## HISTORIC AND DESIGN REVIEW COMMISSION

**HDRC CASE NO:** 2016-095  
**ADDRESS:** 415 MARY LOUISE  
**LEGAL DESCRIPTION:** NCB 6703 BLK 13 LOT 3  
**ZONING:** R6 H  
**CITY COUNCIL DIST.:** 7  
**DISTRICT:** Monticello Park Historic District  
**APPLICANT:** David Whitworth  
**OWNER:** David Whitworth  
**TYPE OF WORK:** Construction of a carport  
**REQUEST:**

The applicant is requesting a Certificate of Appropriateness for approval to increase the footprint and height of an existing non-historic carport. The new carport will be 22'x25' with a 15' ridge height.

415 MARY LOUISE  
SITE PLAN

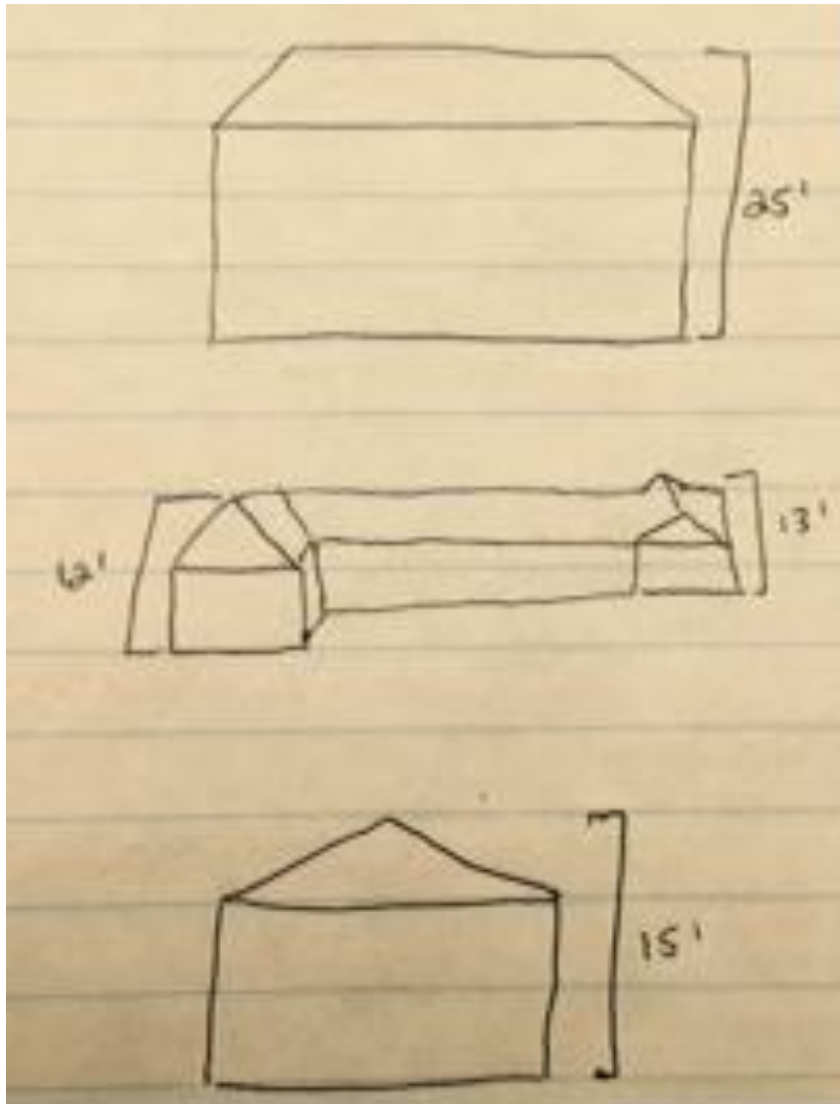
- g. The applicant is proposing to build a new carport that is not attached to the garage. The new carport is 22' x 25', 550 square feet, has a front gable roof with a 15' ridge height and a 10' clearance to accommodate a new vehicle. The side setback remains at 5 feet. According to the Guidelines for New Construction 5.A., new outbuildings should be no larger in plan than 40% of the principal historic structure's foot print, and should be visibly subordinate to historic structures. In regards to height and massing, staff finds the proposed carport 15' ridge height overwhelms the historic garage. This is inconsistent with the guidelines. Staff recommends that the applicant consider a flat roof which would be transparent from the public right-of-way and relate to the historic garage.

The ridgelines are 12' for the casita, 13' for the garage, 15' for the carport and 25' for the main house.

Staff does not recommend approval based on findings g.

Old Carport

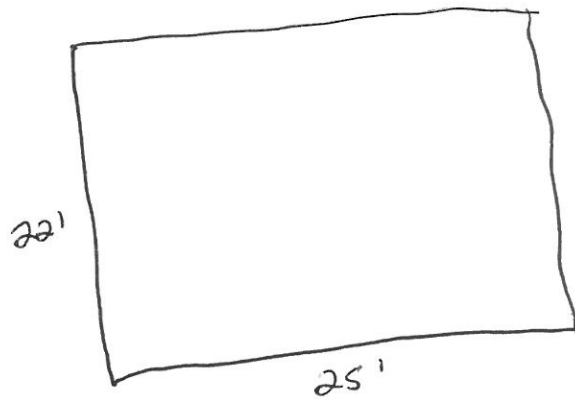
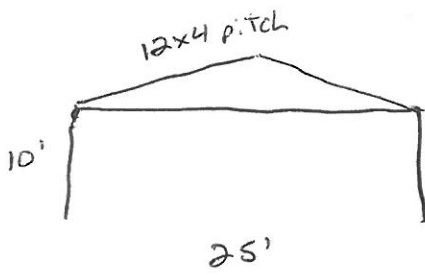
- d. The previous carport had a flat roof, and was 18' x 17' x 8' and located at the end of the existing driveway, with a 5' side setback.
- e. The applicant is proposing to rebuild the carport in the location of the previous carport with the same access. Staff made a site visit on March 5, 2016, and found that rear garages and carports along the block. This is consistent with the Guidelines for New Construction 5.B, which recommends new outbuildings match predominant garage and carport orientations.
